ENGINEER'S SUPPLEMENTAL INSTRUCTIONS NO. TWENTY-NINE (29)
(Via Posting to FTP Site and Electronic Mail)

RE: Harold D. Thompson Regional Water Reclamation Facility (HDTRWRF)-Phase 1
ENGINEER'S SUPPLEMENTAL INSTRUCTIONS TWENTY-NINE (ESI-029)

1 PARTIAL VIEW -- PROCESS EQUIPMENT AND PIPING PLAN

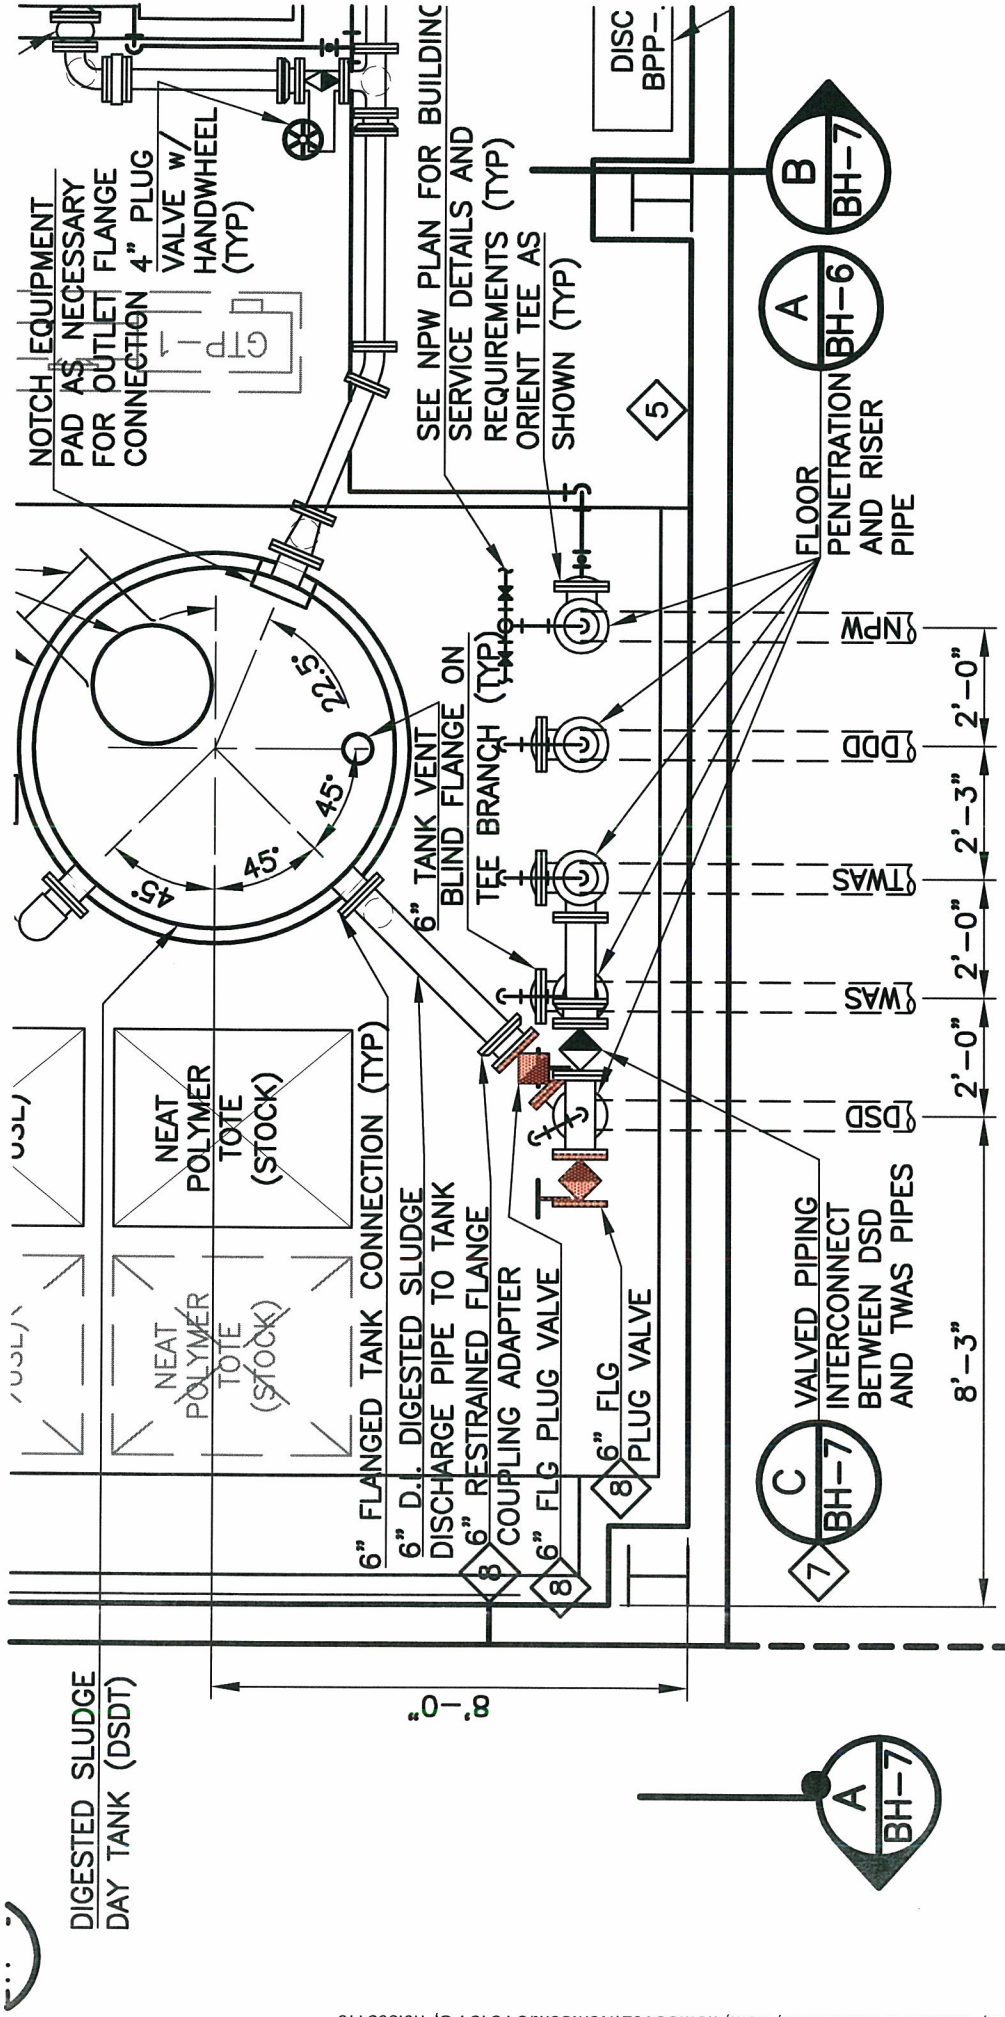
This ESI-029 provides information on two additional items of work required for the project. The first item of work involves additional valve installations on the digested sludge discharge piping in the Biosolids Handling Complex to accommodate the interim transfer of digested solids to a tanker truck. The drawings attached to this ESI-029 provide the installation details and work requirements for these valve installations. Refer to the list of attachments at the end of this ESI-029 for an itemization of those drawings and details.
